Response to National Grid Document 8.4.12.2 – Response to ISH2 Action Point 27 (Masterplans)

A Landscape Too Sensitive for Pylons: The Case for Protecting Ardleigh

Response to the Applicant's deadline 5 submissions relating to visualisations

Map showing proximity to Dedham Vale National Landscape. (see below)

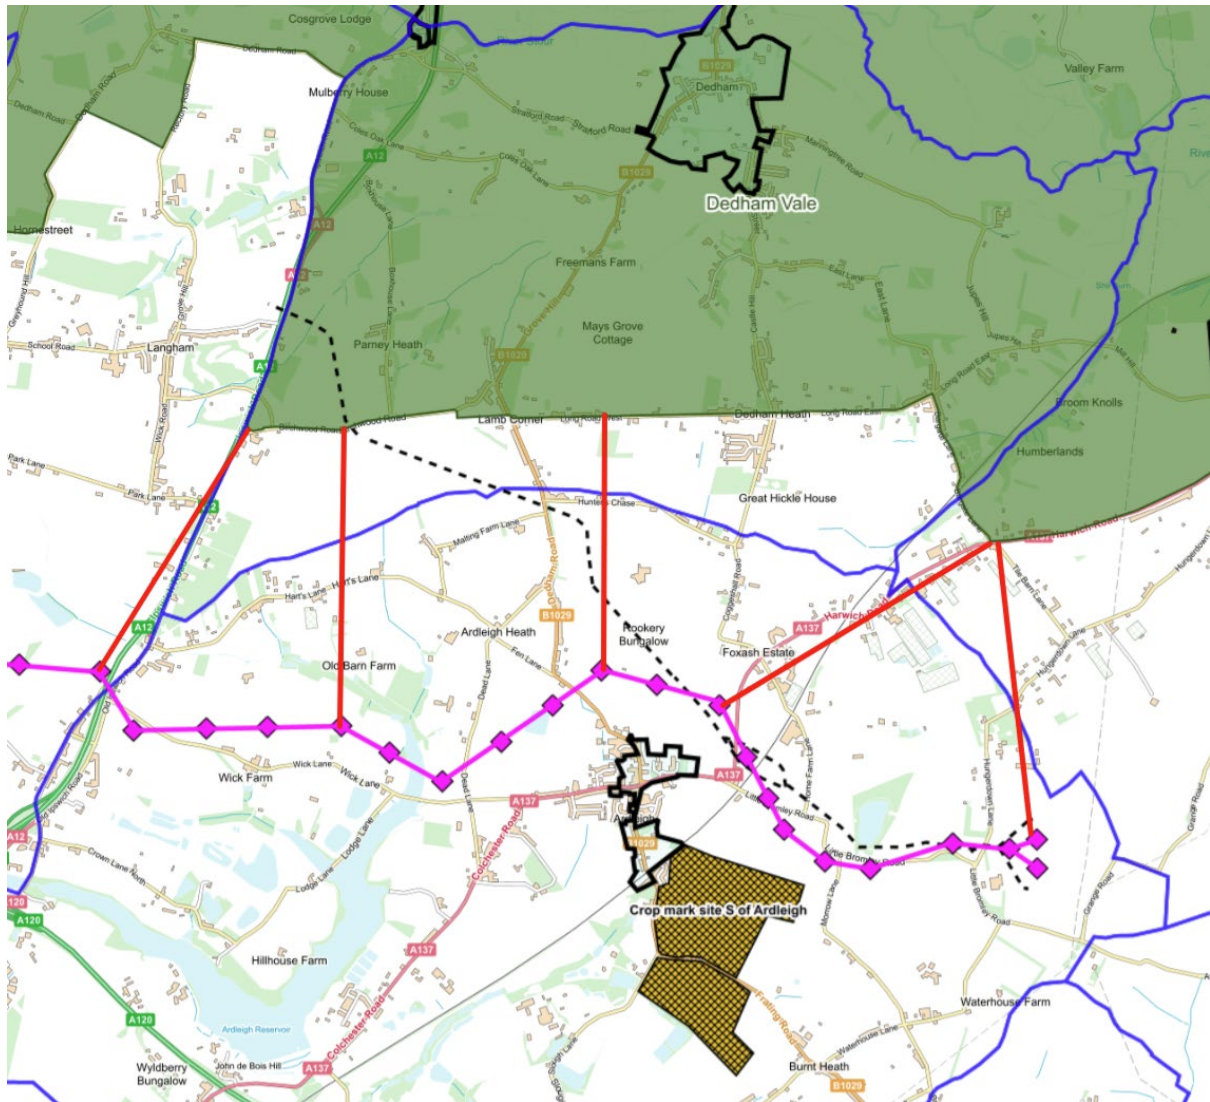
That same reasoning should be applied consistently to the rest of the Ardleigh area affected by the proposed re-emergence of pylons: visible from the Dedham Vale National Landscape (see attached map).

National Grid's decision to underground the Ardleigh–EACN section is an implicit, and explicit, admission that this landscape is too sensitive for overhead pylons. The Examining Authority should therefore require National Grid to provide a consistent, policy-compliant approach by avoiding pylons in the Ardleigh area.

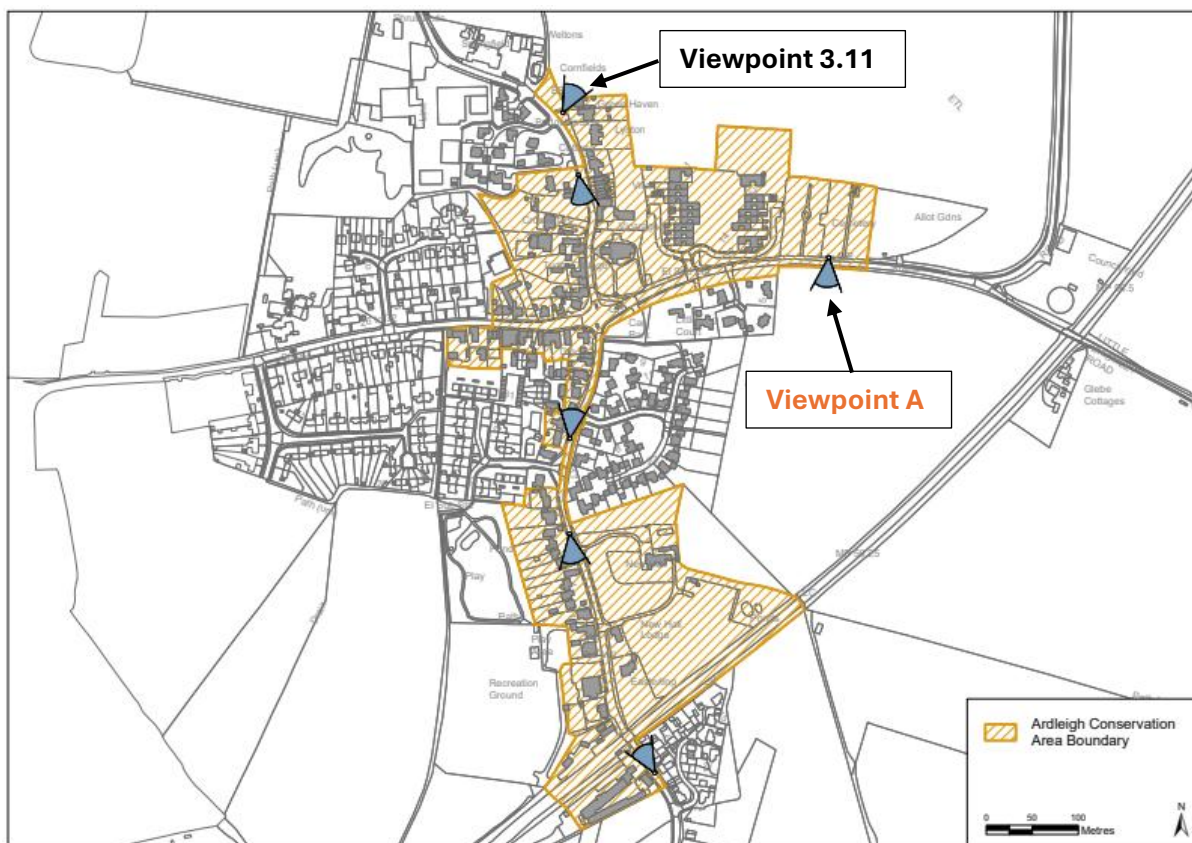
- The following statement is very concerning: *“The conclusions of the Landscape and Visual Impact Assessment (LVIA) in 6.13 Environmental Statement Chapter 13 - Landscape and Visual [APP-226] or the Historic Environment assessment in 6.11 Environmental Statement Chapter 11 - Historic Environment [AS-068] will not change as a result of adding new illustrated viewpoints”*.

- These are viewpoints that the Applicant has not previously assessed, despite earlier requests from ALBA. It is therefore premature to state that the assessments would not change.

- Five of these requests date back to the 2024 statutory consultation – please refer to [REP4-319] for details.
- Of the 11 viewpoints requested by ALBA, the Applicant has stated that it will only be producing visualisations for 2 of these (Bounds Farm, Hungerdown Lane and at the intersection between PRow Ardleigh 5 and PRow Ardleigh 7/Green Lane).

- In addition, the Applicant has committed to producing the new visualisations for deadline 6 instead of deadline 5 as requested by the ExA.
- The Applicant acknowledges *“the effect on visual receptors would be major and significant”* for 5 of the 9 viewpoints that were dismissed. ALBA considers this level of harm to be sufficient justification alone for including viewpoints relating to these visual receptors.
